BUREAU OF LAND MANAGEMENT
SUNDRY NOTICES AND REPORTS ON WELLS

1. Type of Well ☑ Oil Well ☐ Gas Well ☐ Other					. Well Name and No. HT FEDERAL 1	
Name of Operator Contact: NATALIE E KRUEGER CIMAREX ENERGY COMPANY OF CQ-Mail: nkrueger@cimarex.com					9. API Well No. 30-025-39974-00-X1	
3a. Address 600 N MARIENFELD STREET MIDLAND, TX 79701	. (include area code) I 0-1936)-1940		MALJAMAR , Yeso, W

13. Describe Proposed or Completed Operation of the proposal is to deepen direction. Attach the Bond under which the wo following completion of the involved testing has been completed. Final Aldetermined that the site is ready for formarex has changed plans reattached revised BOP diagram	ally or recomplete horizontally, and will be performed or provide operations. If the operation respondonment Notices shall be filed in all inspection.) egarding the BOP. Please	give subsurface the Bond No. or sults in a multiple ed only after all i	locations and meas in file with BLM/BL e completion or rec requirements, inclu	ured and true verti A. Required subst ompletion in a ne- ding reclamation,	cal depths of all perti equent reports shall b w interval, a Form 31	inent markers and zones. e filed within

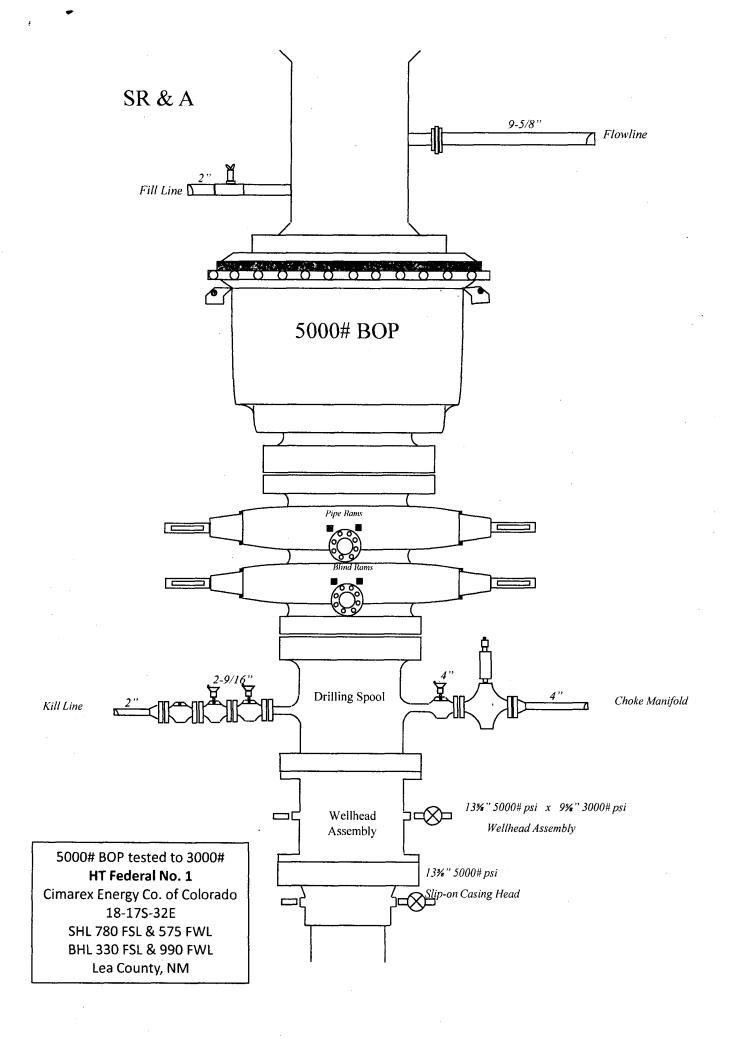
running of production casing, the well will be equipped with a 5000 psi BOP system tested to 3000 psi.

BOPS will be tested by an independent service company to 250 psi low and 3000 psi high. Hydril will be tested to 250 psi low and 3000 psi high.
